**SITE PLAN**  
 SCALE: 1"=30'-0"

**STRUTHERS-POLARIS RMC**  
 NEW BUILD  
 847 STRUTHERS RANCH RD.  
 COLORADO SPRINGS, CO 80912  
 EL PASO COUNTY, COLORADO

# Site Development Plan\_V1.pdf Markup Summary

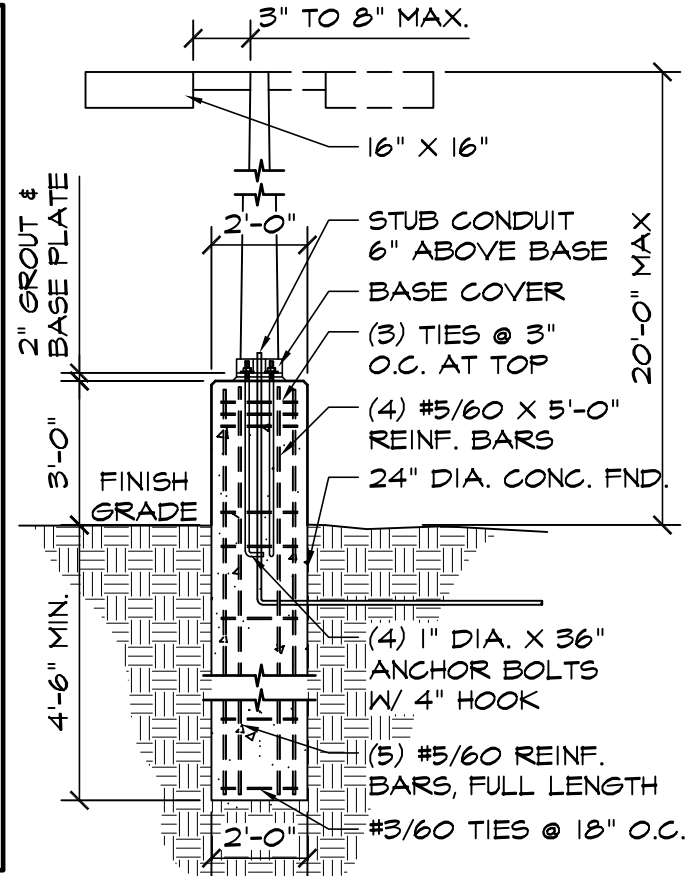
Show on plan:  
 Location of all existing and proposed utility lines and associated infrastructure  
 Shown on utility plan provided by Civil  
 Location of all no-build areas, floodplain, drainageways and facilities  
 All easements, setbacks, and no build areas clearly shown on plan  
 Location of existing and proposed water and wastewater infrastructure, including well and septic locations, if applicable  
 Shown on utility plan provided by Civil  
 Provide the layout and location of all off-street parking, loading and other vehicular use areas, unless otherwise depicted in detail on a separate parking plan. If depicted on a separate parking plan then depiction of the parking areas are required  
 All these areas are shown on this plan  
 Any additional information required pursuant to any associated conditions of approval or plat notes.

Show & label the existing crossspan  
 Shown and labeled on plan

Updated on plan  
 Label access curb radius.

Coordinate with traffic engineer to determine if stop sign at driveway entrance is needed.

Please add this note on the plan:  
 The parties responsible for this plan have familiarized themselves with all current accessibility criteria and specifications and the proposed plan reflects all site elements required by the applicable ADA design standards and guidelines as published by the United States Department of Justice. Approval of this plan by El Paso County does not assure compliance with the ADA or any regulations or guidelines enacted or promulgated under or with respect to such laws.

The Traffic Analysis noted that the right turn lane threshold is met. Provide the right turn lane or submit a deviation request for the ECM Administrator's consideration.  
 Updated traffic report included with resubmittal

Label access width. Per ECM 2.4.1.E maximum width is 40 ft.  
 Shown and labeled on plan

Callout to remove and replace existing ramps to current standards per ECM Details SD\_2-41, and SD\_2-42  
 Updated on plan

verify and update label to identify the width of existing sidewalk. The Struthers Ranch Fil 2 construction drawings shows 5' sidewalk for the local road.  
 Revised the proposed sidewalk width to 5'

Correct to 128,066.4sf 2.94 acres (Combined acreage of Lot 1 & 2)  
 Updated

update label to identify the width of existing sidewalk. If existing is 6' wide then a transition taper may be required to go down to 5' wide proposed sidewalk.  
 Updated

vacate of lot line application is required if Lots 1 & 2 are being combined as shown on this site plan.  
 Lot line will be vacated along with any coordinating easements as shown here on plan

Updated traffic report included with resubmittal  
 Show sight distance easements required on site plan per traffic study. See snippet. Note: there shall be no obstructions that are taller than 30' above Struthers Road flowline per ECM 2.3.6.G.2. It appears parking lot retaining walls are already exceeding allowed heights per Struthers Road flowline elevation of 6757'.

Add: Open space, landscaping, and impermeable surface percentage

Preparers Info. listed  
 Provide plan preparer name, telephone number, and email

Note Added

Total count is 29 with 27 standard stalls and 2 ADA stalls  
 Updated

**11 RETAINING WALL DTL (6'-0" TO 12'-0") HIGH**  
SCALE: 1/2"=1'-0"

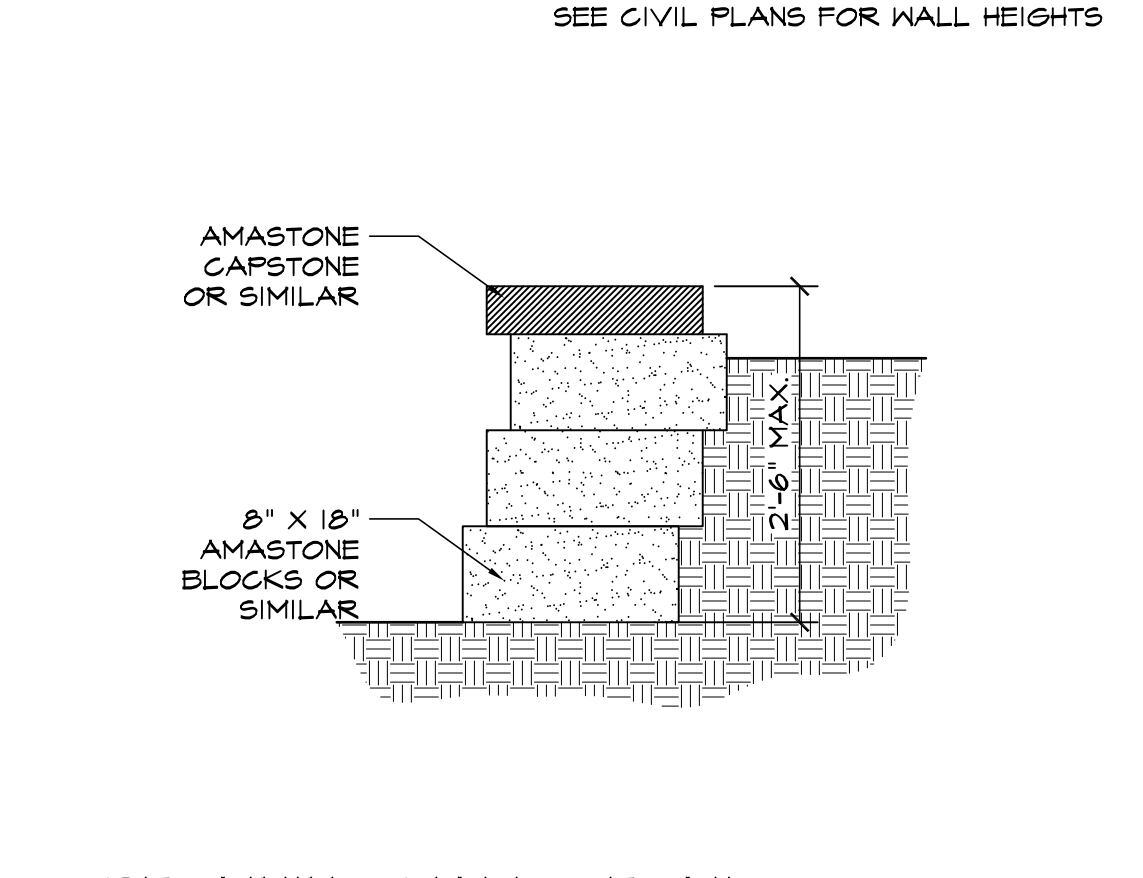
Note: a building permit is required for retaining walls that are 4' or taller.
